RESIDENTIAL PLAN CORRECTION SHEET

ADDENDUM TO Permit No. 01243

Location 1217 INDIANA AVE

subject RESIDENCE TO BE LOCATED ON 1217 INDIANA AVE.

MAIN BATH

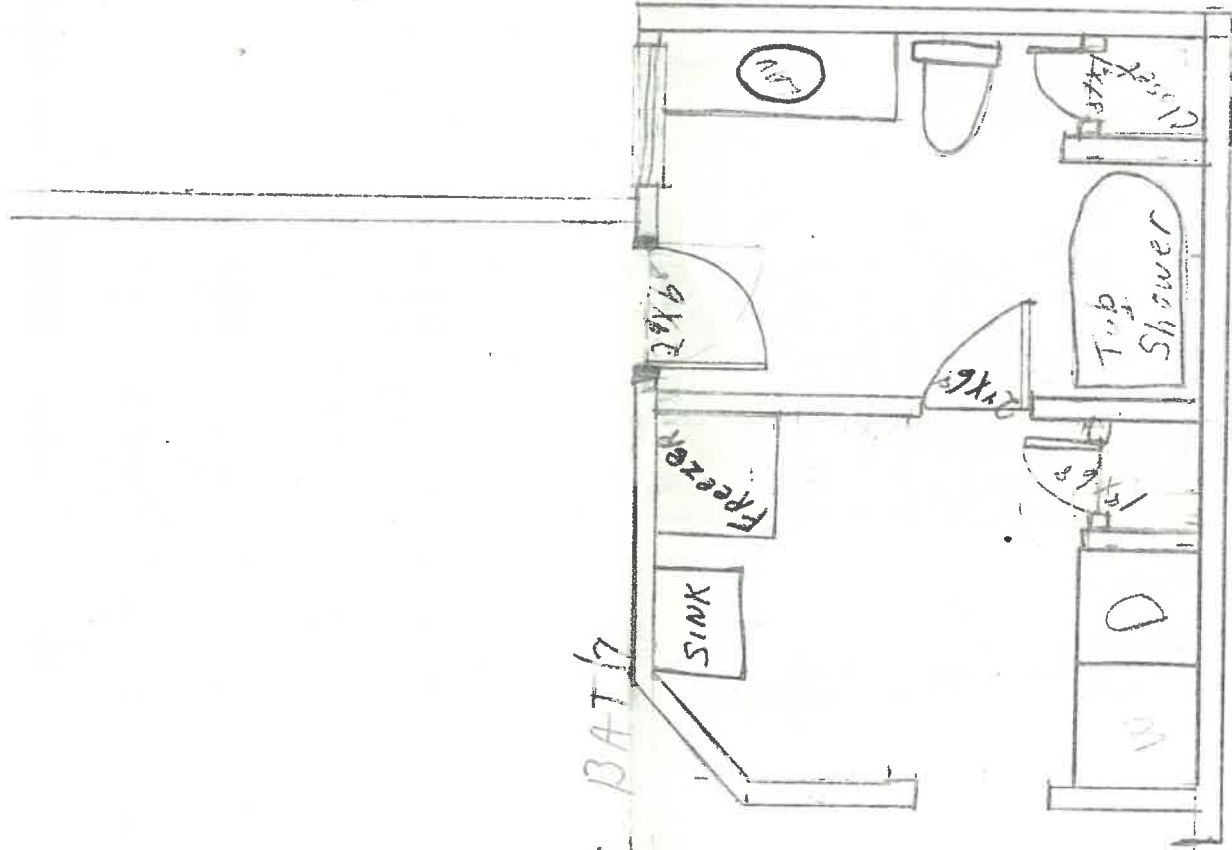
2x6 CEIL JOISTS

11'-8" SPAN

20 # P.S.F. LIVE LOAD ON CEILING

10 # P&F DEAD LOAD ON CEILING

O.K. TO USE 2x6 @ 16" O.C. FOR SPAN

TYPE = 700  
 SPAN = 33FT. 0IN.  
 SPACING = 1FT. 0IN. ON CENTER  
 SHORT TERM LOADING INCREASES  
 LUMBER STRESSES INCREASED = 1.15  
 PLATE RATING INCREASED = 1.15  
 TOP CHORD SLOPE = 5.000/12.000  
 BUTT CUT = 0.25 INCHES

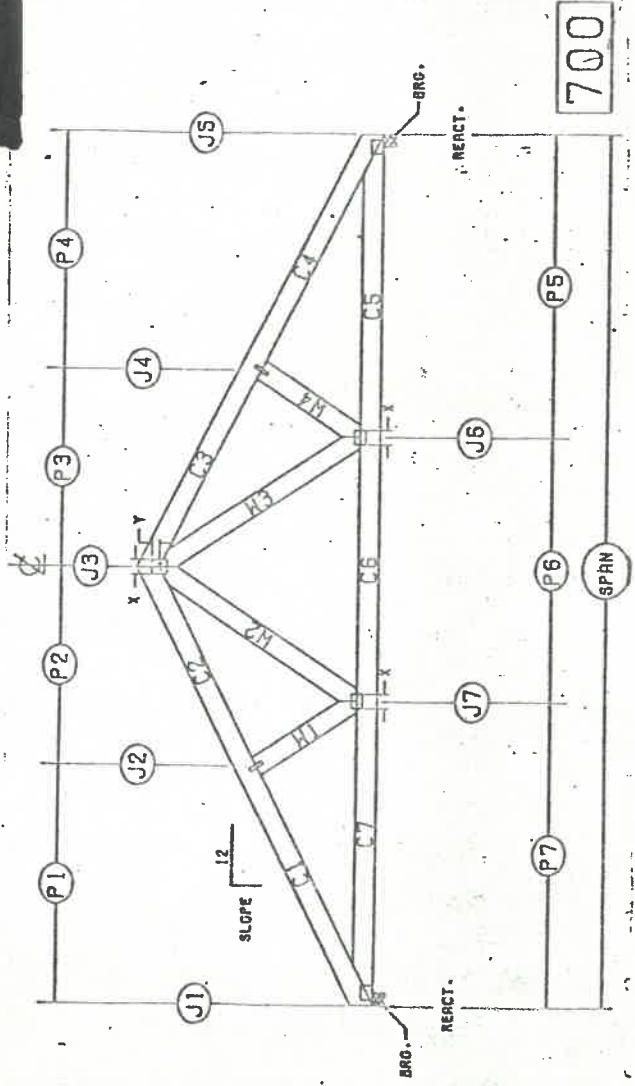
I HAVE REJECTED YOUR TRUSS DIAGRAM DUE TO INSUFFICIENT  
BOTTOM CORD LOADING. I WILL ACCEPT A LETTER FROM YOU  
THAT YOU WILL INSTALL TRUSSES WITH  
THE FOLLOWING LOADINGS WITH THE  
STIPULATION THAT TRUSS DIAGRAMS  
BE FURNISHED BEFORE THE TRUSSES  
ARE INSTALLED,

TOP CORD	L.L.	20.0 P.S.F.
	D.L.	10.0 P.S.F.
BOT CORD	L.L.	20.0 P.S.F.
	P.L.	10.0 P.S.F.
TOTAL LOAD		60.0 P.S.F.
